To: T10 Technical Committee
From: Rob Elliott, HP (elliott@hp.com)
and Mallikarjun Chadalapaka (cbm@rose.hp.com)
Date: 19 June 2002
Subject: T10/02-232r0 SAM-2 SPC-3 SBC-2 SSC-2 Clearing effects of I_T nexus loss

Overview

Figure 1. Power on, wakeup, hard reset, logical unit, and I_T nexus loss relationships

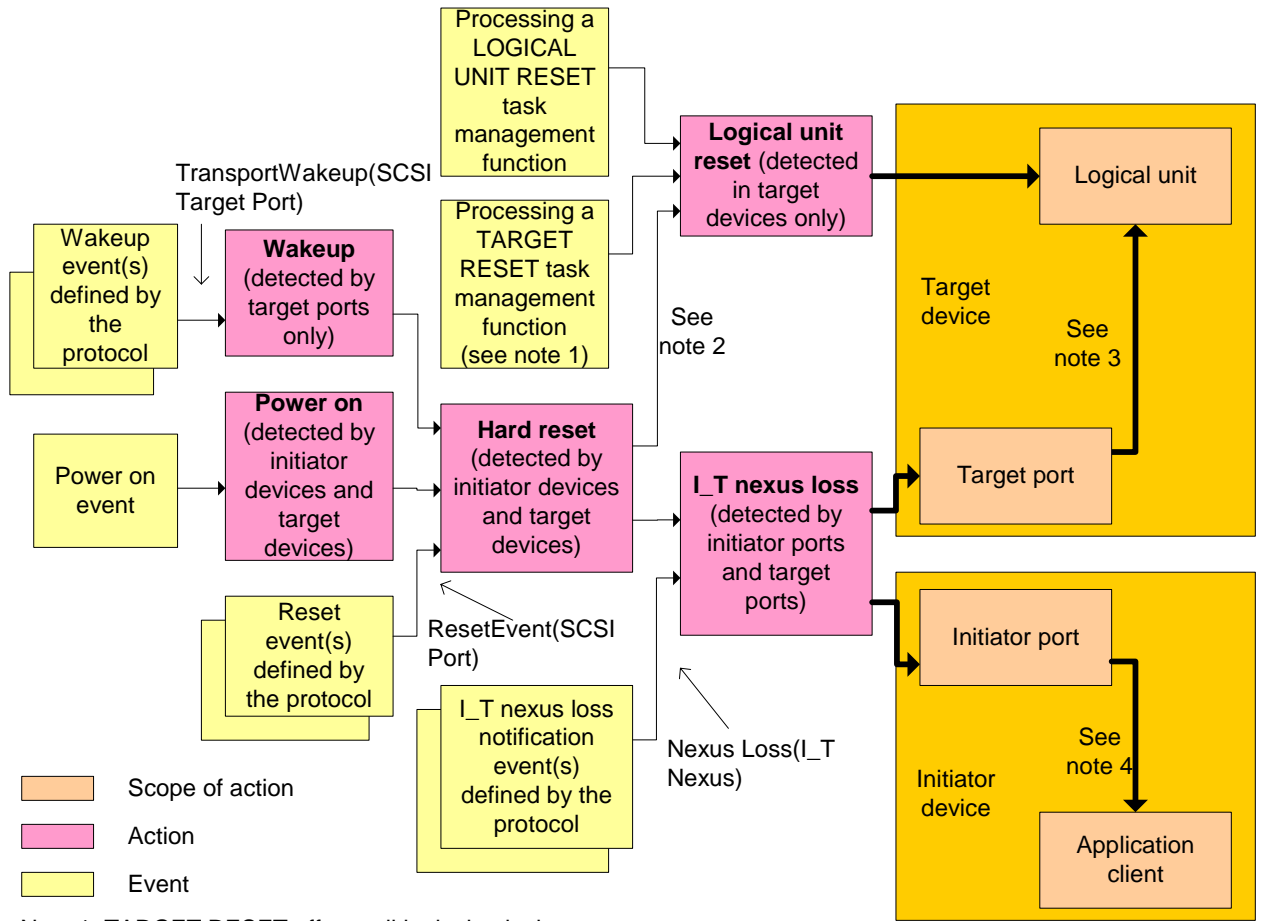
Figure 1 shows the relationships between power on, wakeup, hard reset, logical unit reset, I_T nexus loss, and their associated events.

Note 1: TARGET RESET affects all logical units in a target device to which the I_T nexus has access.

Note 2: (Hard reset notification event) Hard reset affects all logical units in a target device. The cause of the hard reset is also communicated (wakeup, power on, or reset event).

Note 3: (I_T nexus loss notification event) I_T nexus loss affects all logical units in a target device to which the I_T nexus has access.

Note 4: (I_T nexus loss notification event) I_T nexus loss affects all application clients in an initiator device using that initiator port.
